## **RERC (Grid Interactive Distributed Renewable Energy Generating Systems) (First Amendment) Regulations, 2023 [Draft]**

## CER Comments

*Figure 1: RE generator with inter-state sale of RE power through open access*

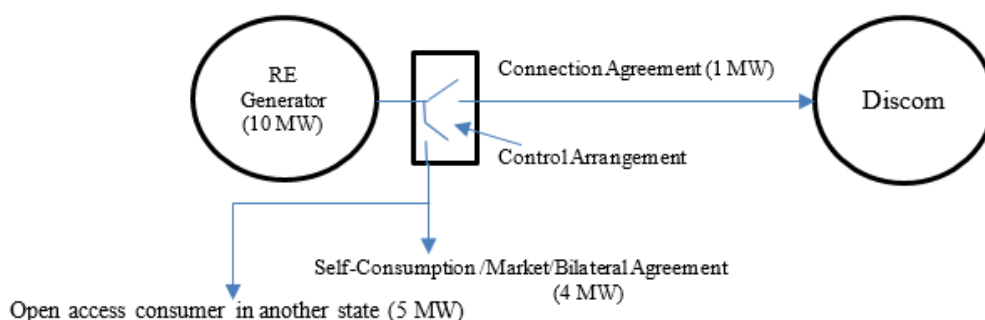
A scenario as illustrated in following figure 1 may occur wherein the installed capacity of a generator (say, 10 MW) is greater than the connection agreement with the Discom (say 1 MW) and 5 MW capacity is contracted with an open access consumer located in another state. In such a case, the open access consumer outside the state should be explicitly recognised as an ‘obligated entity’. Thus the discom should not claim RPO for the RE energy sold to an open access consumer outside the state. Further, it is suggested that the RPO associated with the renewable energy should be applicable only for the capacity agreed for connectivity or the RE electricity injected into the grid, whichever is higher.

Figure 1: Scenario for Despatchable RE generators

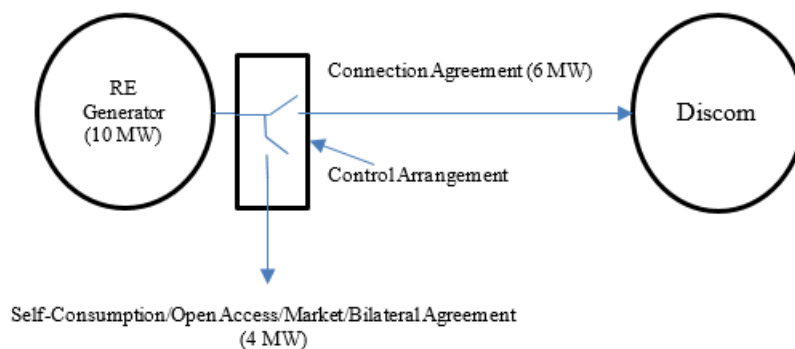
The Variable Renewable Energy (VRE) sources (wind and solar), being non-despatchable, can potentially inject the electricity generated out of total capacity (which may be more than the capacity agreed in the connection agreement) as mentioned in the above clause. This justifies relevance of the above clause. However, in case of despatchable RE sources, a RE generating plant would be able to control the energy generated and injected into the grid. Under such circumstances, the generators may be allowed to seek a connection agreement for a capacity lower than the installed capacity. The excess generation over this limit may not be counted.

Earlier the net billing arrangement between the Renewable Energy Generating System and the Discom(s) was calculated based on minimum Capacity Utilization Factor (CUF), without considering the maximum generation. The proposed net billing arrangement based on AC capacity agreed under connection agreement would benefit the generators to some extent, but at the same time it would discourage further RE capacity addition.

The regulations should also clarify that only excess energy injected into the grid, beyond the connectivity agreement excluding captive consumption (wheeled through the intra-state grid) or sold through any contract or agreement would lapse. For more clarity, the clause should be rephrased as “..... if the peak AC capacity exceeds the above agreed AC capacity, the corresponding excess energy, excluding that scheduled for sale to a third party under any contract or agreement, **injected into the grid** shall lapse.”
